Subject: Article 401 (Condition 11 of the 401 Water Quality Certification)
Article 406 – Water Quality Monitoring Plan
May 18, 2011, Order Issuing New License
Badger-Rapide Croche Hydroelectric Project
Lower Fox River; Outagamie County, Wisconsin
FERC Project No. 2677-019

Water Quality Monitoring Plan

Badger-Rapide Croche Hydroelectric Project

FERC Project No. 2677

WATER QUALITY
SAMPLE LOCATION
OVERVIEW

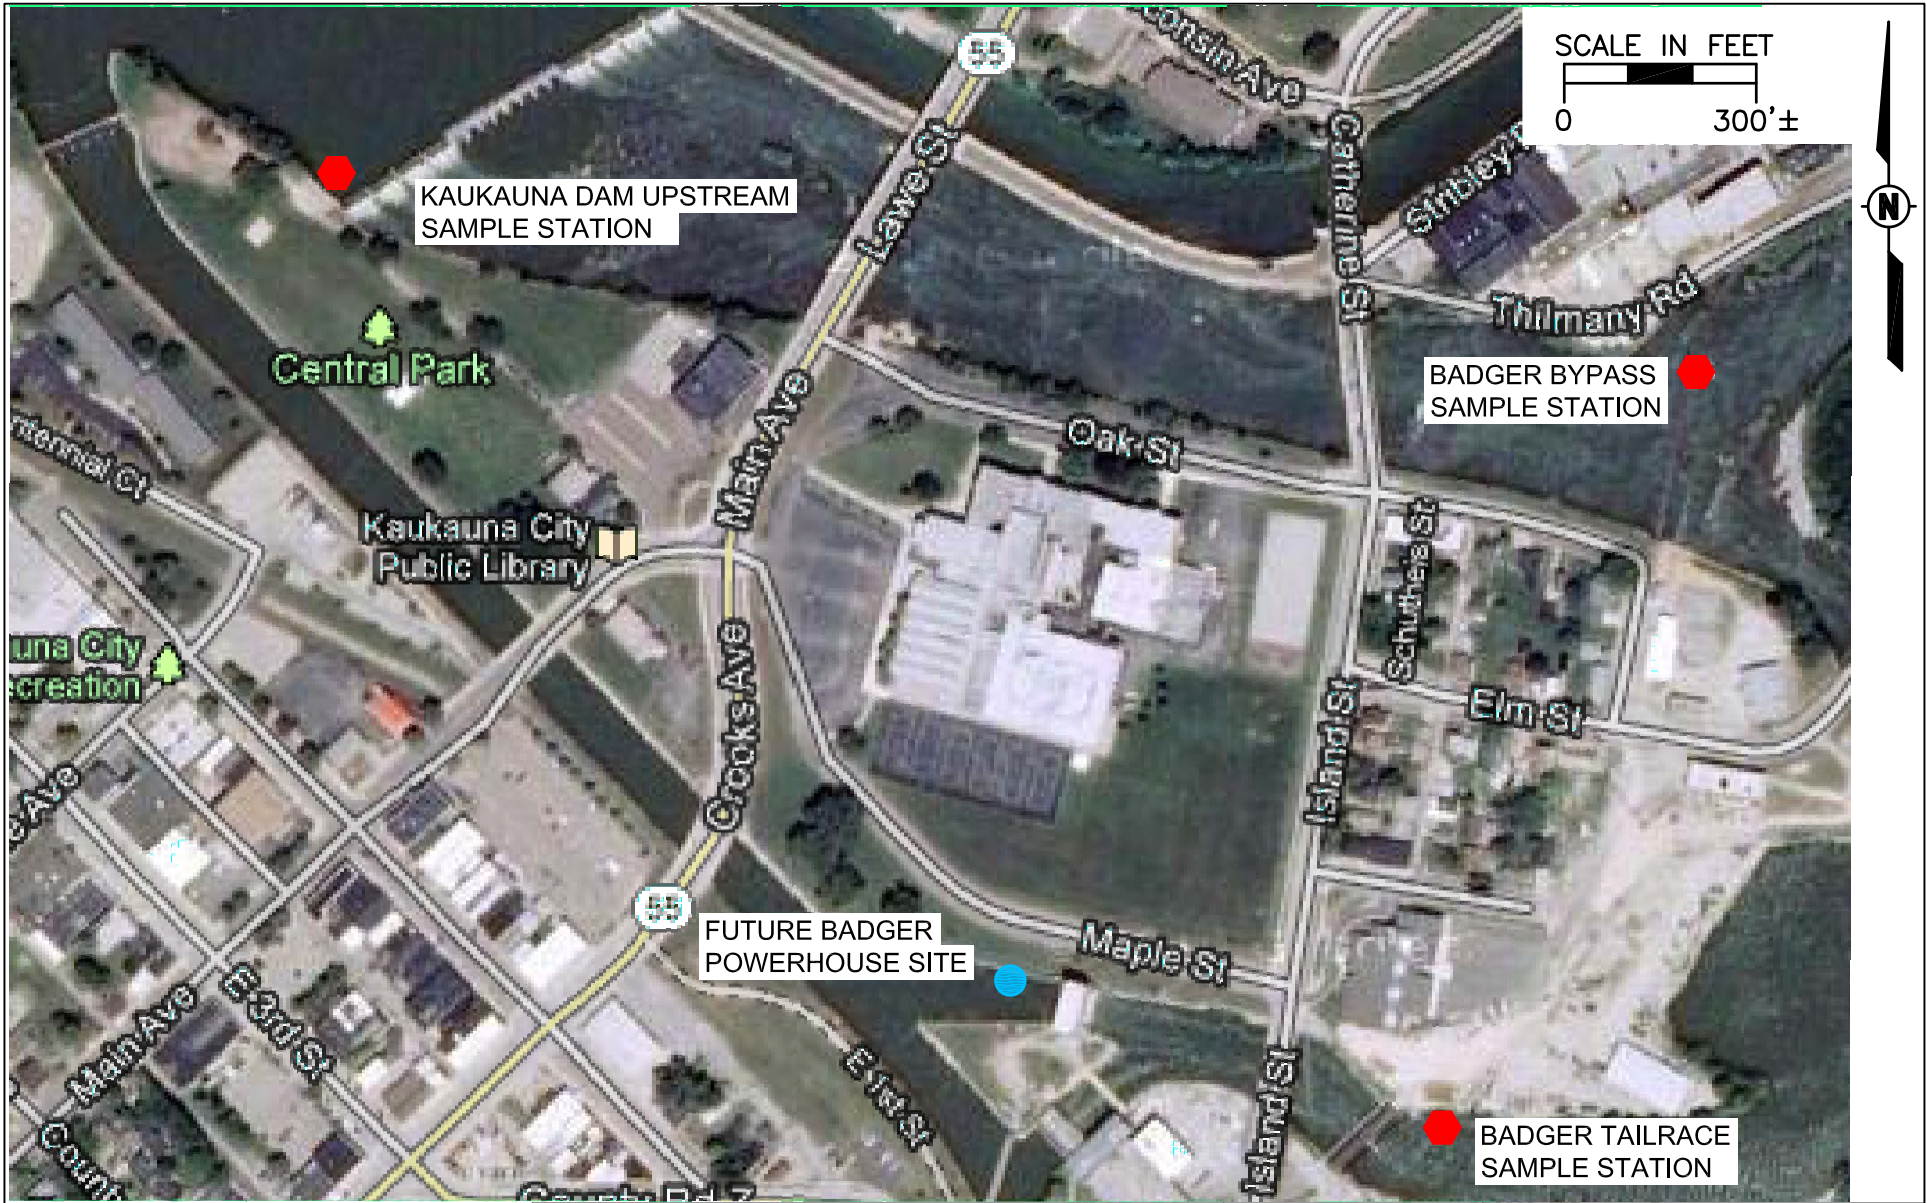
1. Monitoring locations – DNR Water Resources staff approves of the proposed monitoring sites. Please provide a map with Lat Long locations.
2. Sampling parameters – Dissolved oxygen, temperature, nitrate series, pH, flow, water elevation, time of samples, date. The analysis for nitrate series needs to be sent to a certified lab. Nitrate series should be collected during spring spawning events, coordinated with the increase in flows. Collection should include two samples. Meters shall be calibrated and maintained according to manufactures instructions. Cleaning and maintenance records should be kept on site and provided in the annual report. A summary of NR102, state water quality standards should be provided, with a detailed discussion for any discrepancies. Daily min and max reporting values should be reported with daily averages, for temperature, dissolved oxygen, pH, flow, and water elevations.
